**ADDENDUM NO. 1
TO THE BID DOCUMENTS**

Project: Deep Water Dock Uplands Improvements 2016
Addendum Issue Date: February 4, 2016
Bid Date: February 18, 2016 @ 2:00 PM (Thursday)
Previous Addenda Issued: None
Issued By: Carey Meyer
City Engineer
City of Homer
Homer, AK 99603
cmeyer@ci.homer.ak.us

TYPICAL CHIP PAD DETAILS
NTS

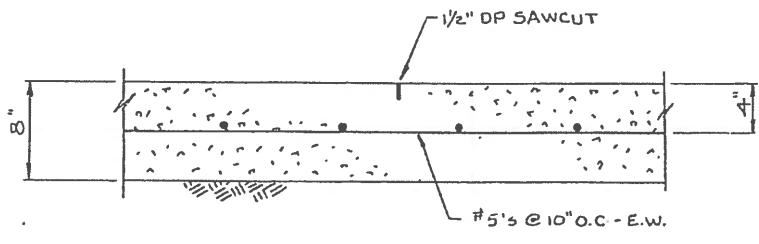
ITEM 2 – How thick is the chip pad concrete slab?

Answer: The typical section of the chip pad concrete slab is attached.

*NOTE: RAISE TOP OF CURB AS REQ'D.
TO MATCH GRADE.

STC 900 PRECAST CONCRETE STORMCEPTOR (900 U.S. GALLON CAPACITY)

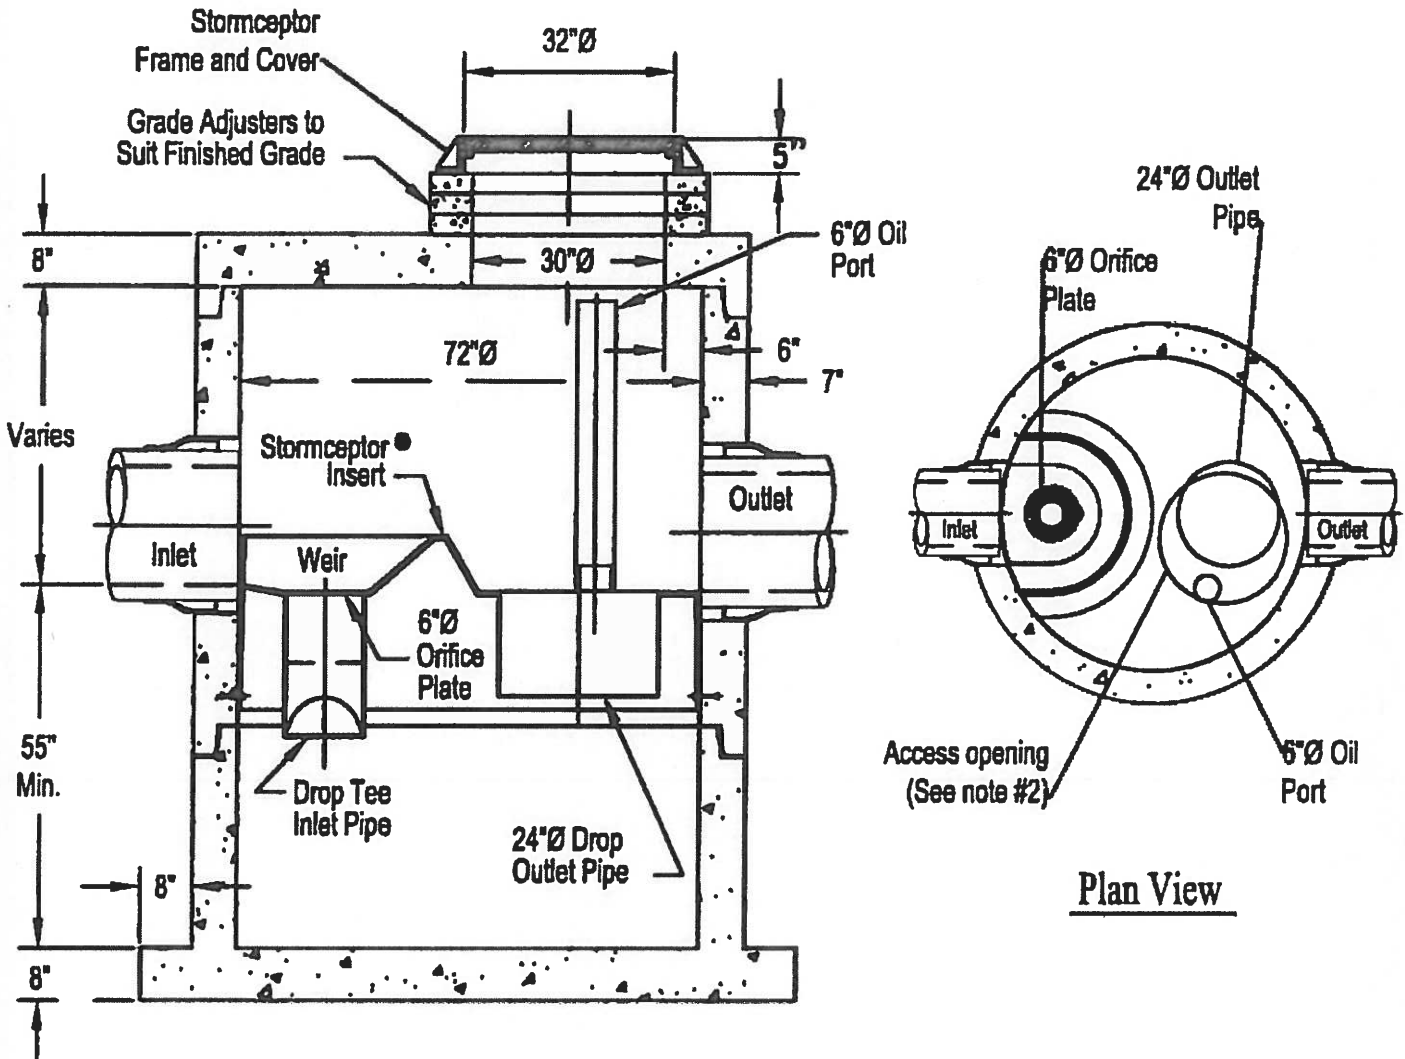
ITEM 3 – Change to "Stormceptor" size

Delete the City provided Stormceptor 1800 and the Contractor provided Stormceptor 1800 shown on the plans and replace both with a Stormceptor 900. See attached revised detail and storm drain profiles. The 900 has a significantly reduced sump bottom depth.
